PSE&G Public Service
Electric and Gas
Company

September 26, 1984

HOPE CREEK GENERATING STATION
DOCKET NO. 50-354
DRAFT SAFETY EVALUATION REPORT
OPEN ITEM STATUS

PENETRATION CONDUCTOR
 OVERCURRENT PROTECTION

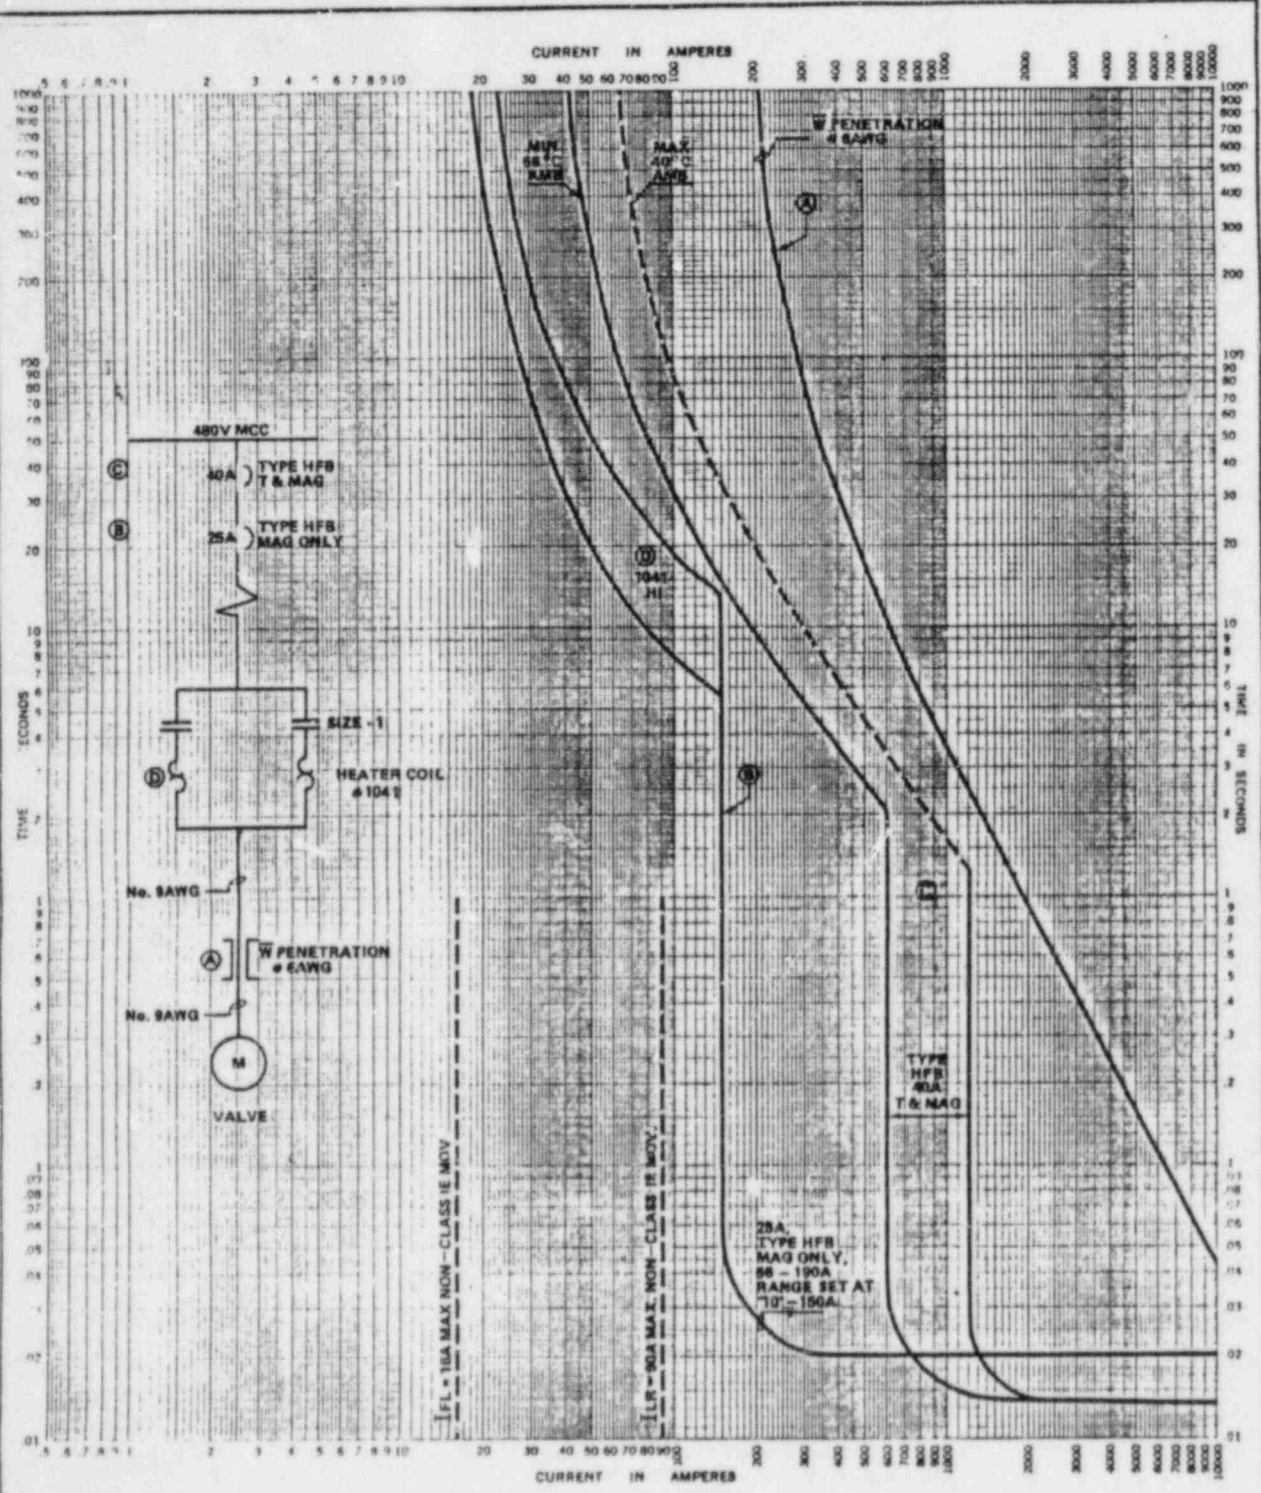
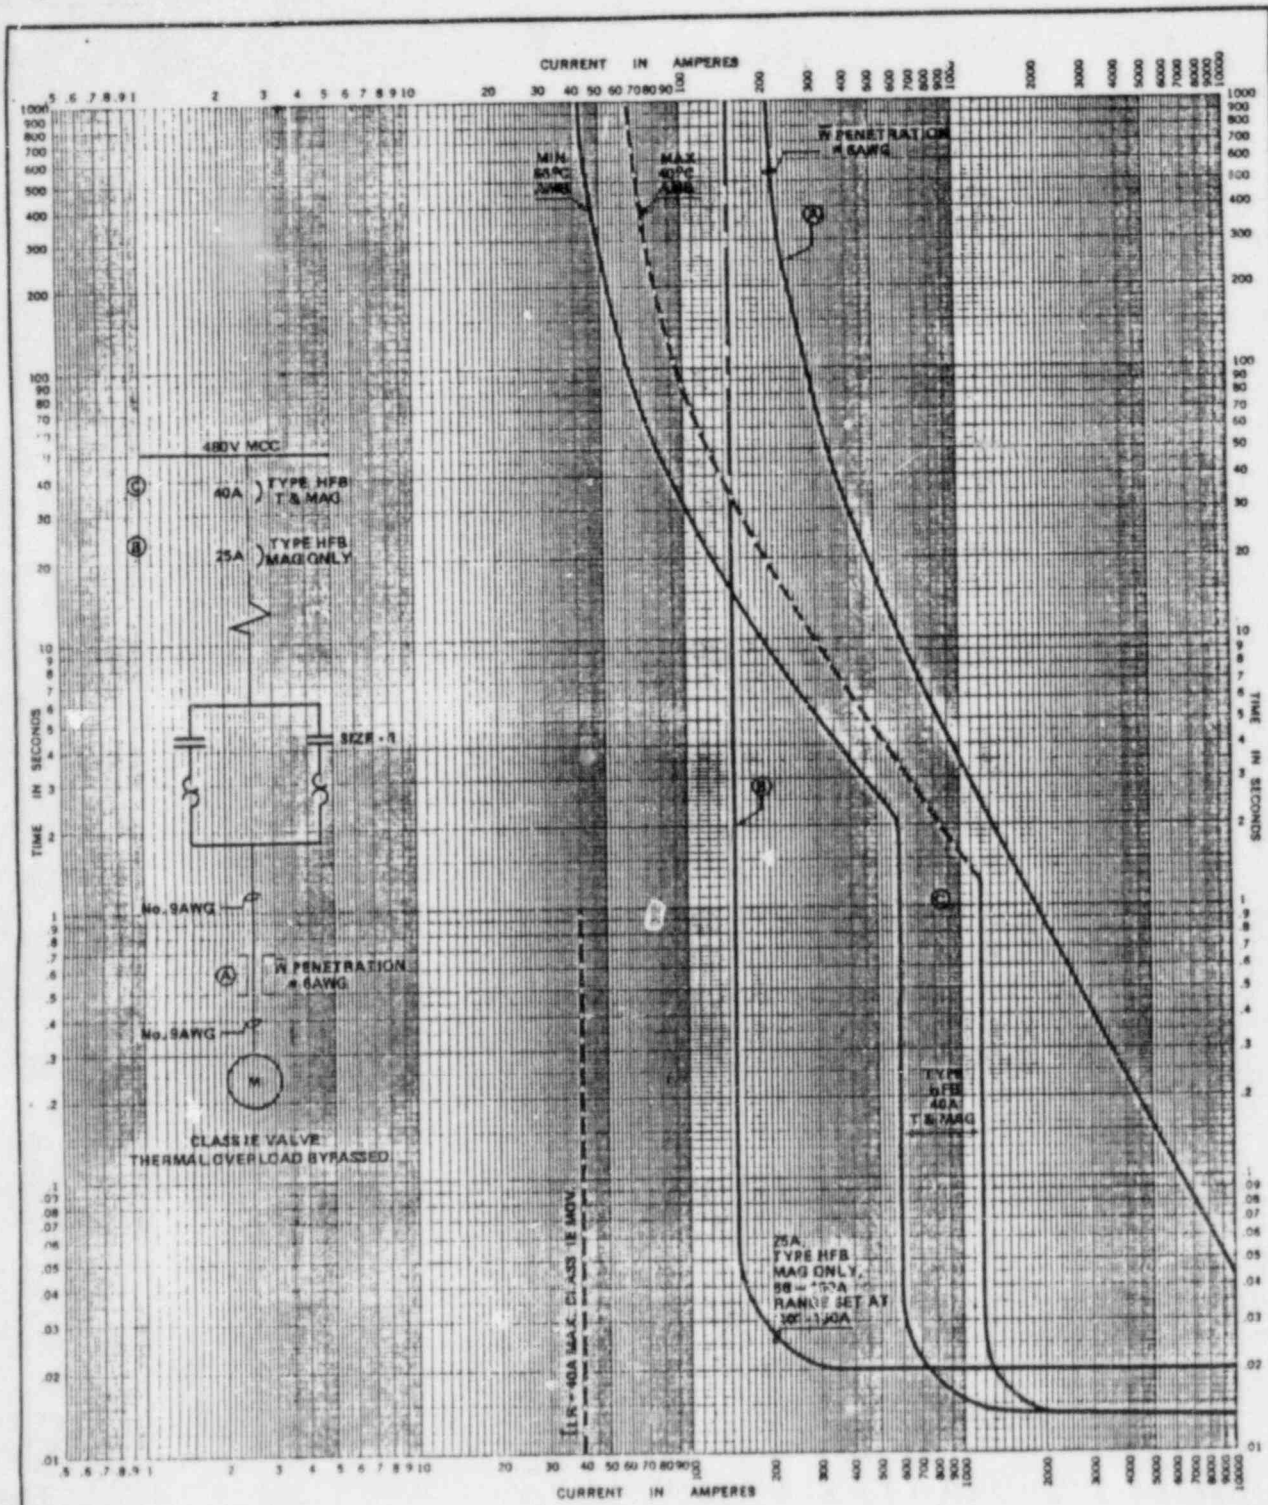
By Amendment 4 to the FSAR, the applicant indicated that coordinated fault-current versus time curves for representative penetration conductors and their protective devices are included in Figures 420.46-1 of the FSAR. Based on a review of these figures, the staff concludes that representative curves for motor differential relay, current transformer, and instrumentation circuits were not included in Figure 430.46-1. Inclusion of these circuits as well as other circuits such that the coordinated fault-current versus time curves is representative of all penetration circuits will be pursued with the applicant.

In addition, the penetration assemblies are designed to withstand, without loss of mechanical integrity, the maximum short-circuit current vs. time conditions that could occur, given single random failures of circuit overload protection devices. Time current characteristic curves, based on tests, of the penetration conductors have been established by the penetration supplier; these curves show the maximum duration of symmetrical short circuit current. Based on these curves the primary and backup protective devices are selected to ensure that the mechanical integrity of the penetrations is maintained. Coordinated fault-current versus time curves for representative penetration conductors and the protective devices are shown in Figures 8.3-17, Sheets 1 to 22.

The test report that substantiates the capability of the electrical penetration to withstand fault current without seal failure for worst case environmental conditions has been submitted under a separate cover.

The testing of all penetration over-current protective devices will be incorporated in the HCGS Technical Specifications.

Figure 430.135-1
 STANDBY DIESEL GENERATOR
 LUBE OIL MAKE-UP TANK

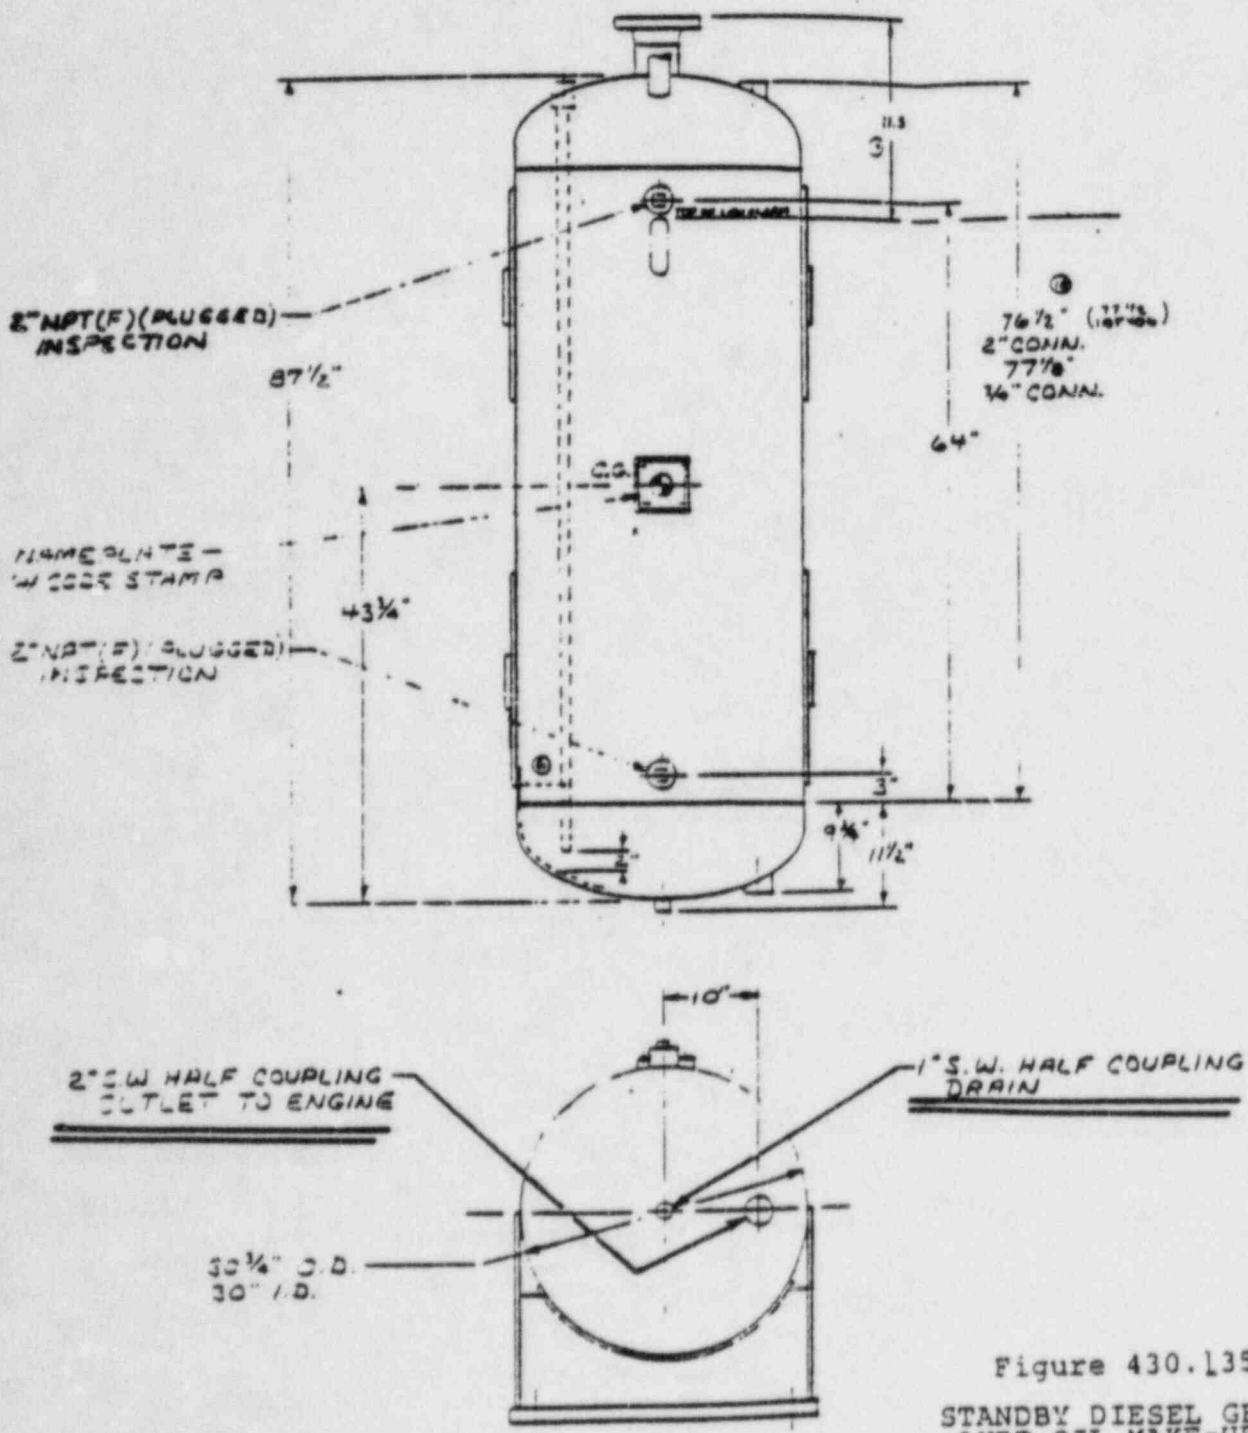
You state in Section 9.5.7.2 of the FSAR and shown in Figure 9.5-27 that lube oil is added to the diesel generator lubricating oil system from a 250 gallon lube oil make-up tank. Provide a discussion on the measures that have been taken to prevent entry of deleterious materials in the lube oil make-up tank. Also discuss what measures have been taken to prevent entry of deleterious materials into the lube oil make-up tank due to operator error during filling operation.

- c. Figure 9.5-27 of the FSAR shows that the diesel generator lube oil make-up tank is provided with an individual fill, vent, and emergency pressure relief vent lines. Indicate where these lines are located (indoor or outdoor) and the height these lines are terminated above finished ground grade. If these lines are located outdoors discuss the provisions made in your design to prevent entrance of water into the make-up tank during adverse environmental conditions, and the tornado missile protection provided.

The lube oil makeup tank bottom is hemispherical. The line to the diesel generator sump is approximately 1.75 inches above the bottom of the dish and is located ten inches off the centerline of the tank, reference figure 430.135-1. Should there be any carry over into the transfer line, it would be trapped in the strainer and/or filter after entering the engine sump.

A normally closed drain valve is provided at the low point of the tank, reference Figures 9.5-27 and 430.135-1. The drain valve will be opened in accordance with plant operating procedures to remove any deleterious sediment, water or other material that may accumulate in the bottom of the tank.
